**Addendum No. 2**

**For Project No. ENG2403730319  
Lincoln Amphitheatre Improvements  
Lincoln State Park  
Spencer County**

Re: Lincoln Amphitheatre  
Phase 3&4 – Amphitheatre Improvements  
Lincoln City, IN  
Project #: LA23102  
DNR Project #: ENG2403730319

## **ADDENDUM #2**

DATE: 3-8-24  
REV: 4-1-24  
UDA PROJECT NO.: LA23102  
ENR PROJECT NO.: ENG2403730319  
SHEET NO.: A6

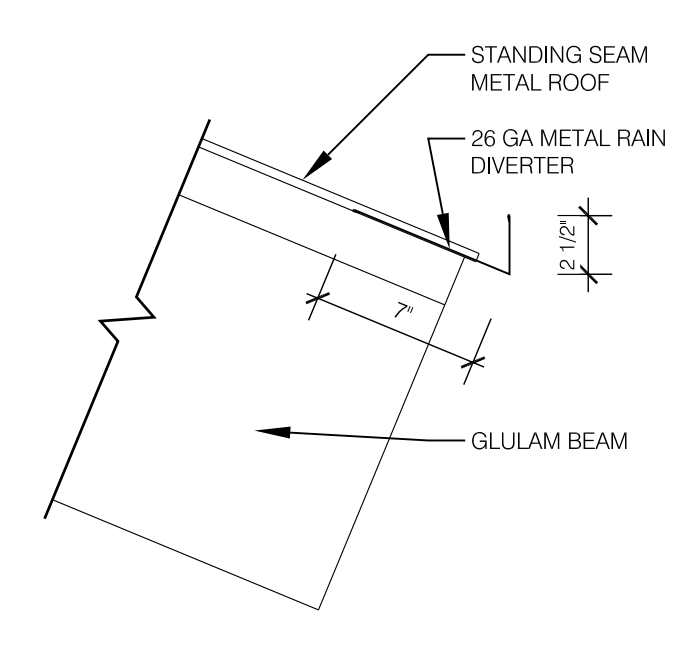
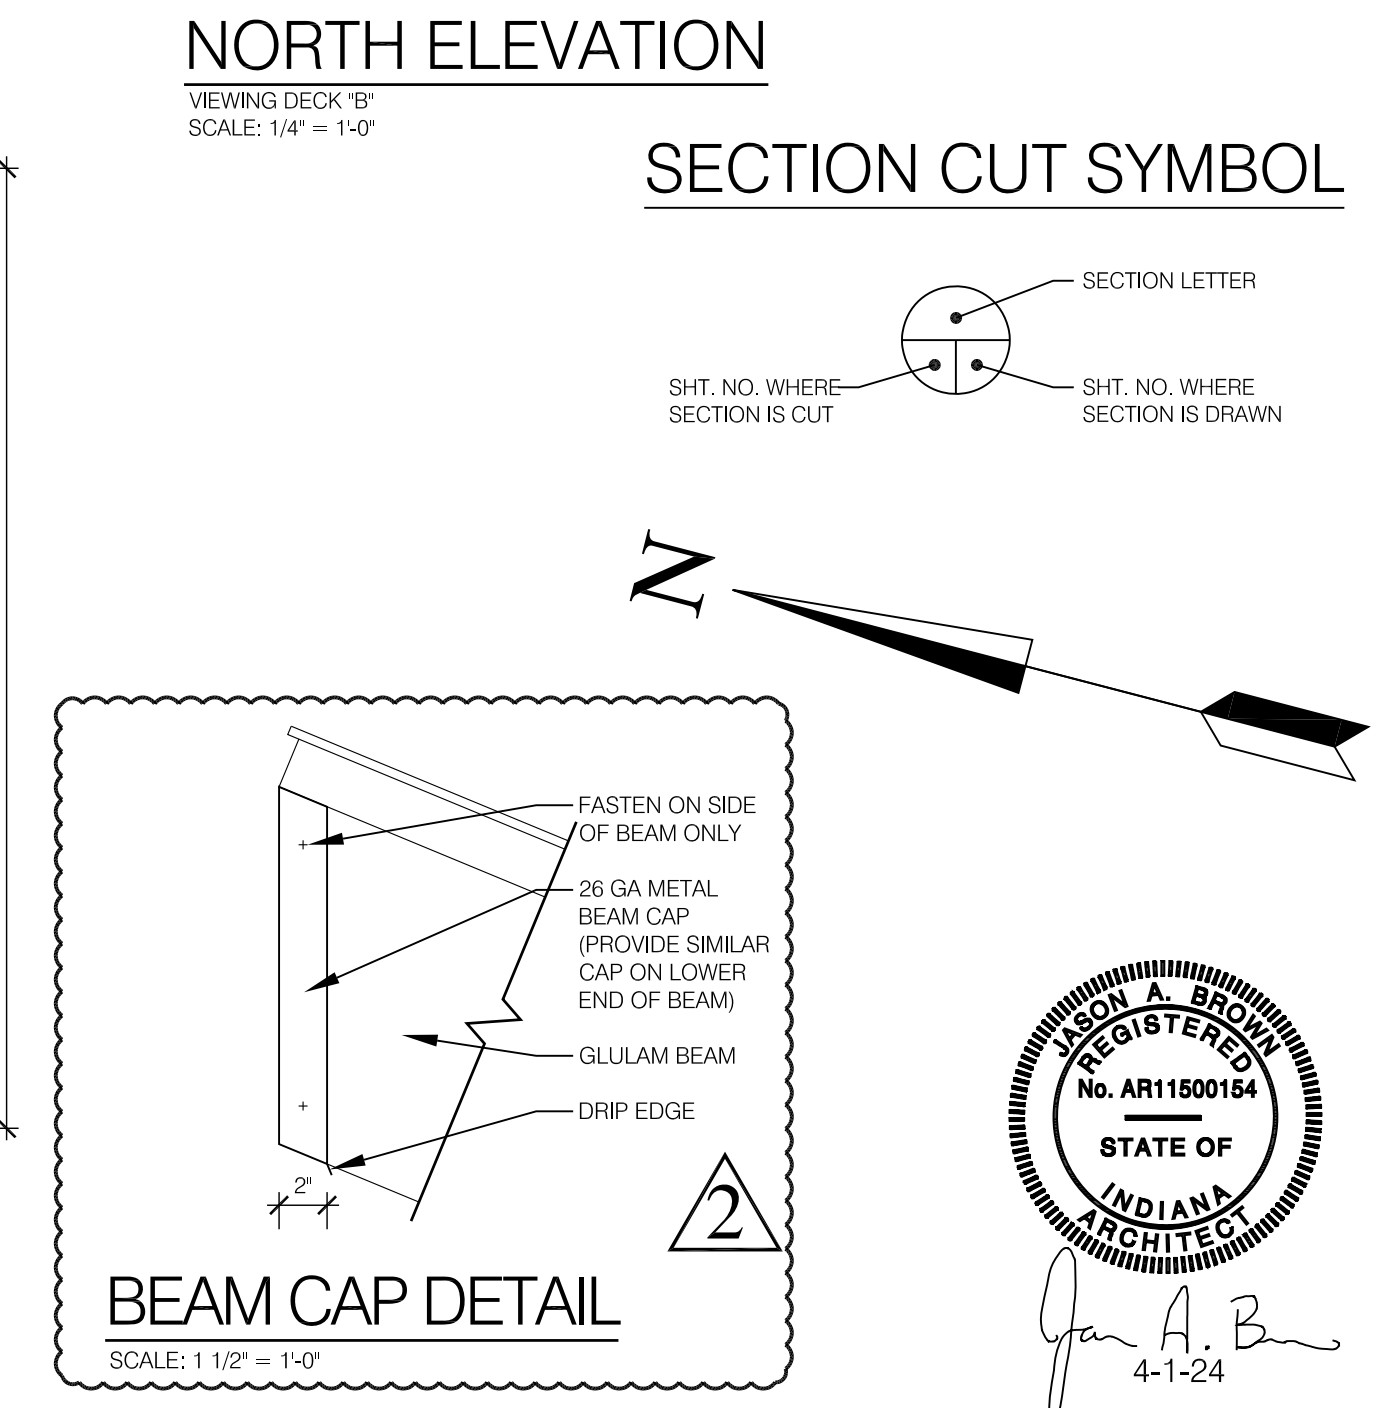
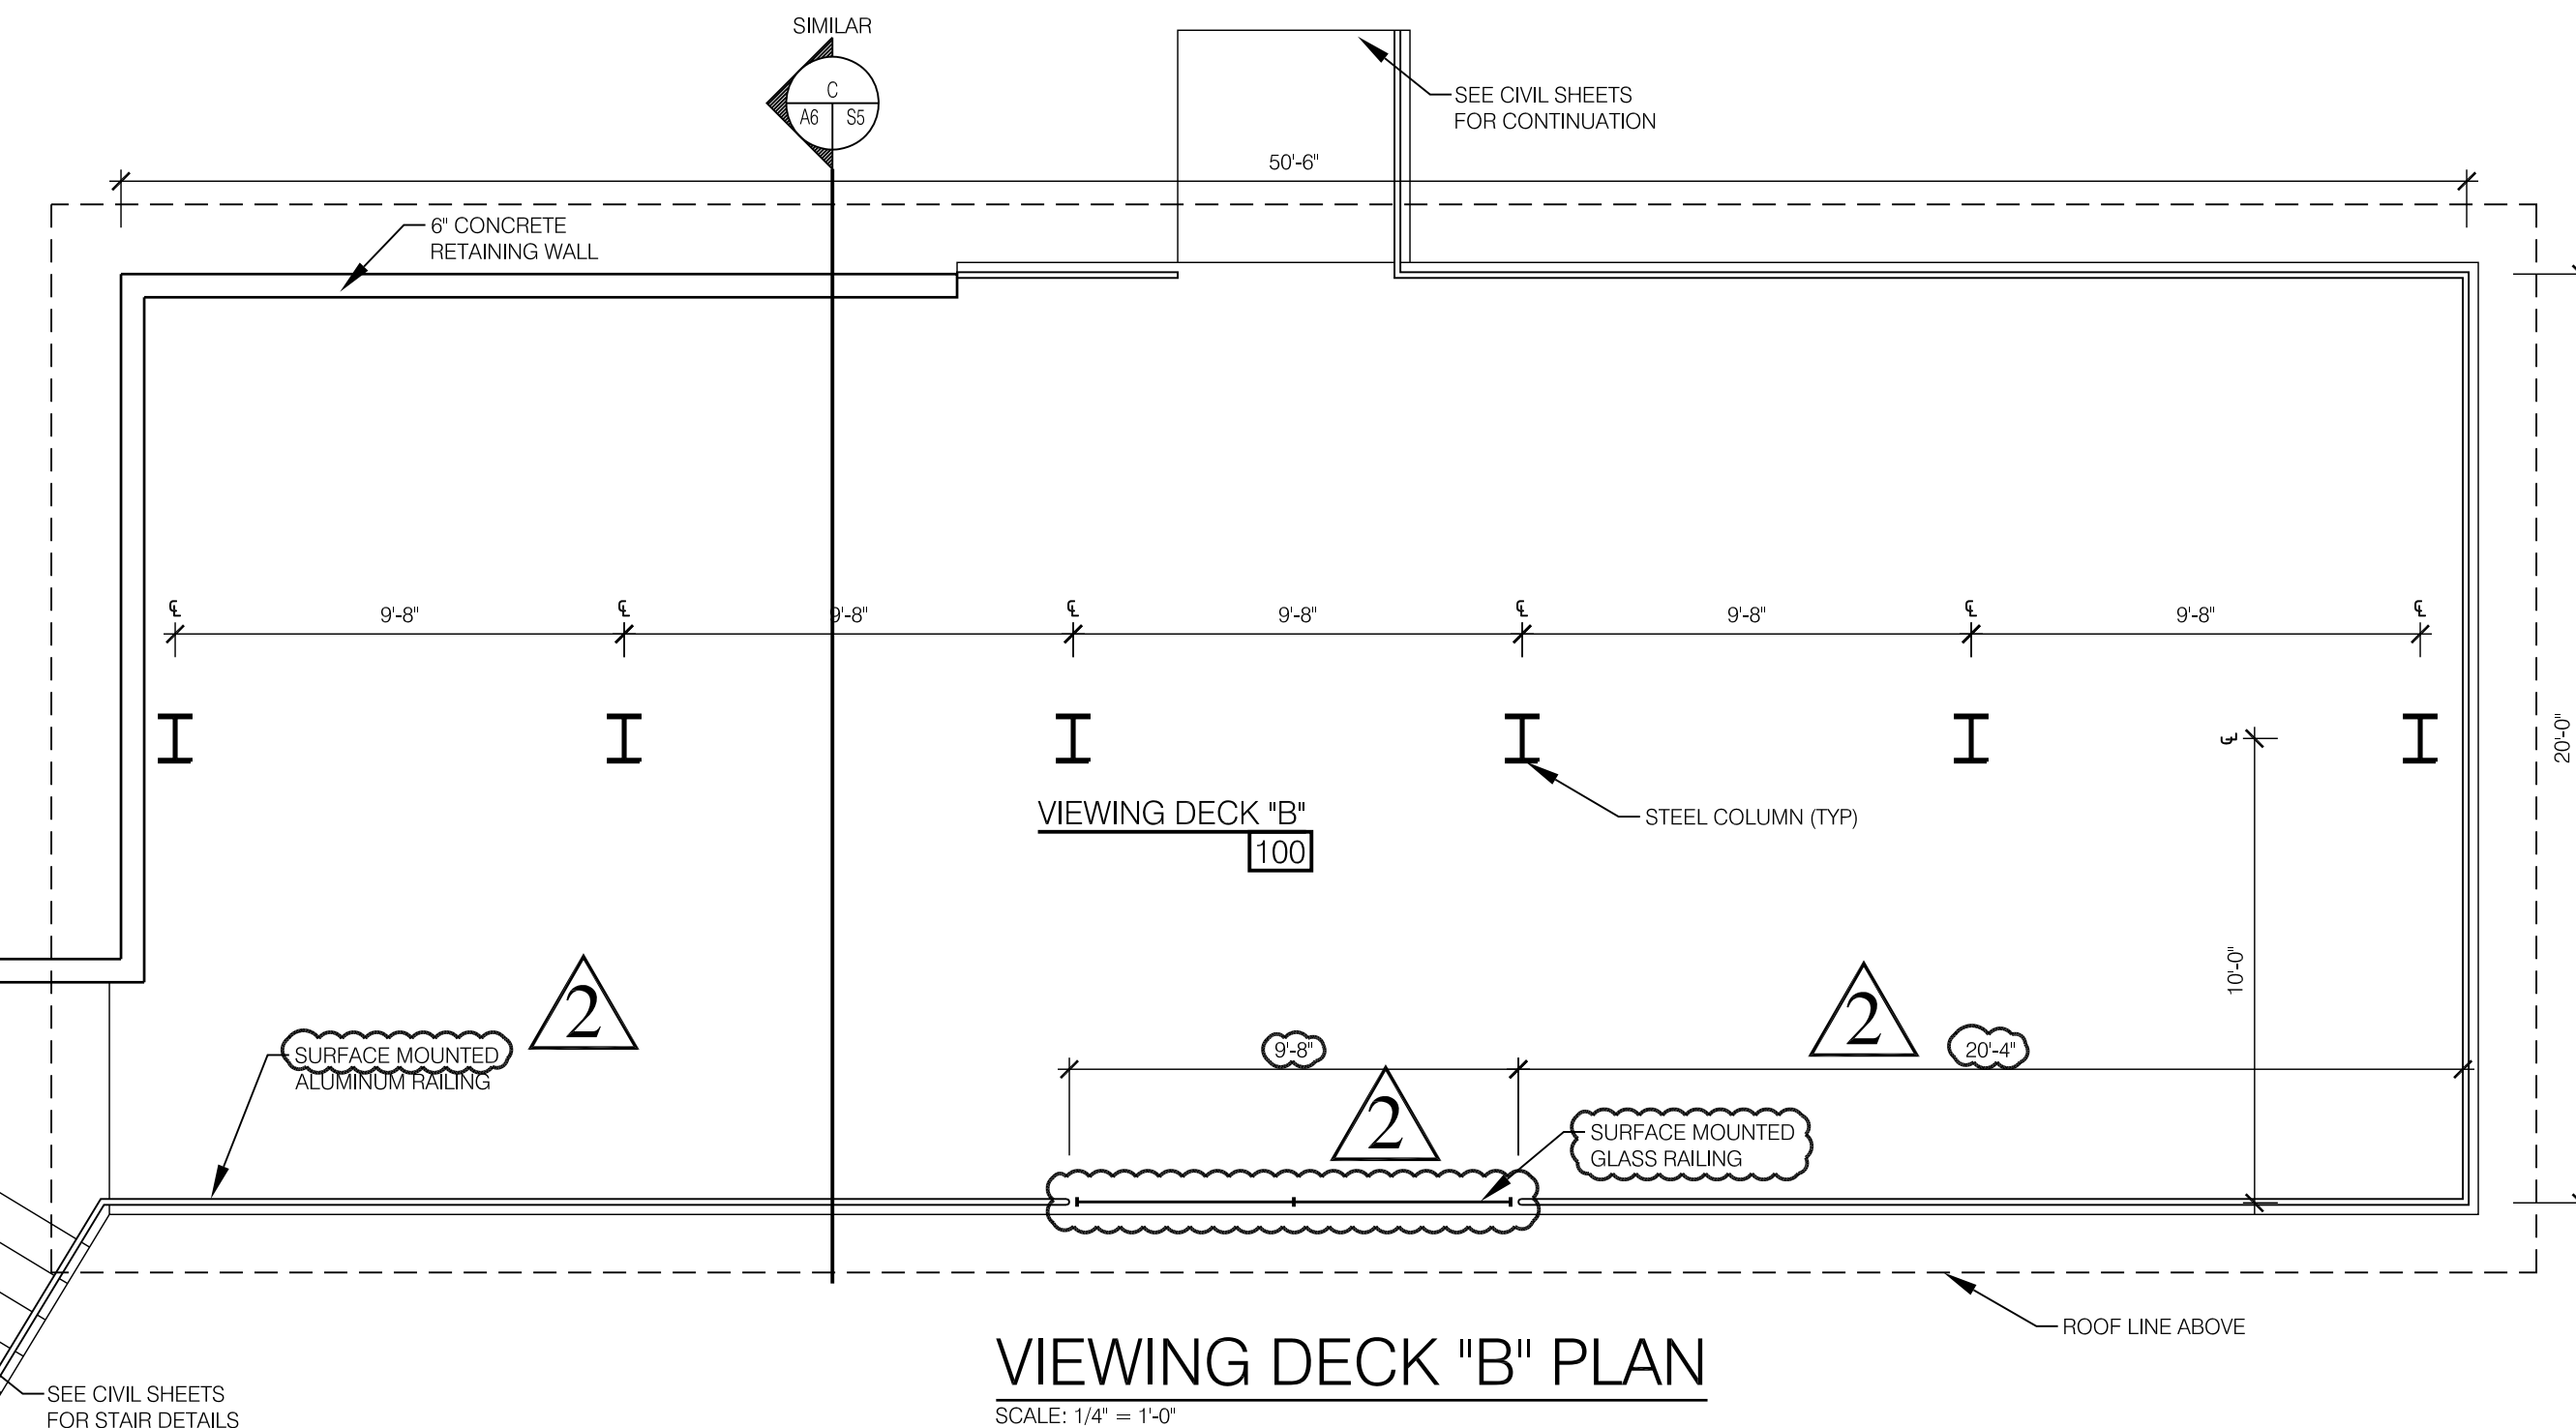
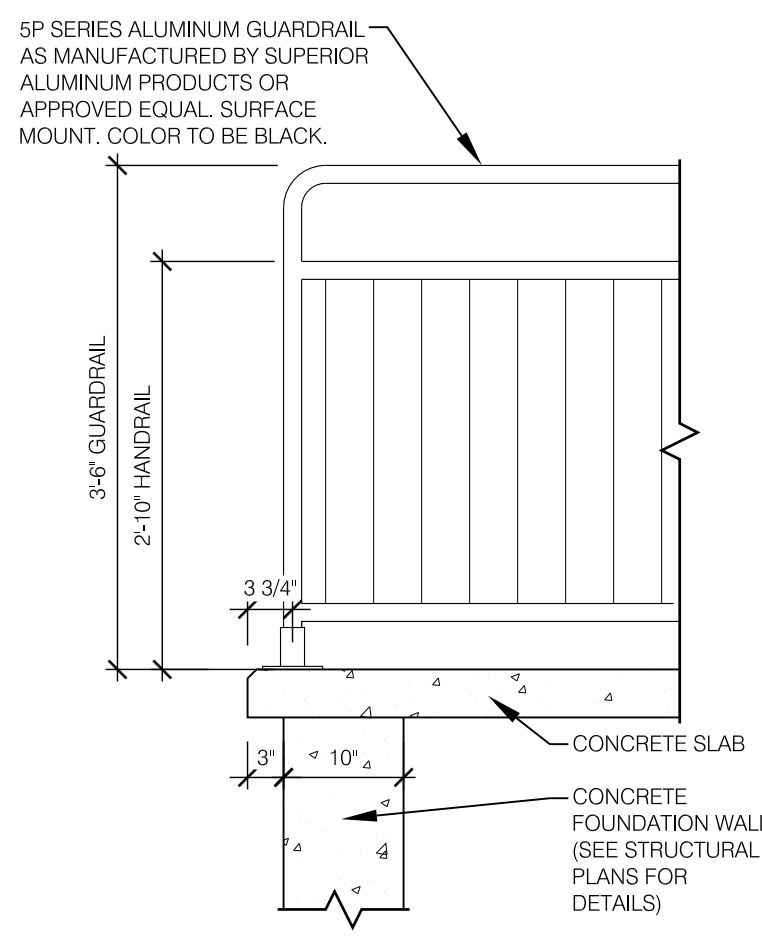
10. Sheets A5 & A6 – See the revisions as shown on the revised sheets included with this document. The revisions relate to dimensions for the glass railing as well as a beam cap flashing detail at the ends of all of the glulam beams.
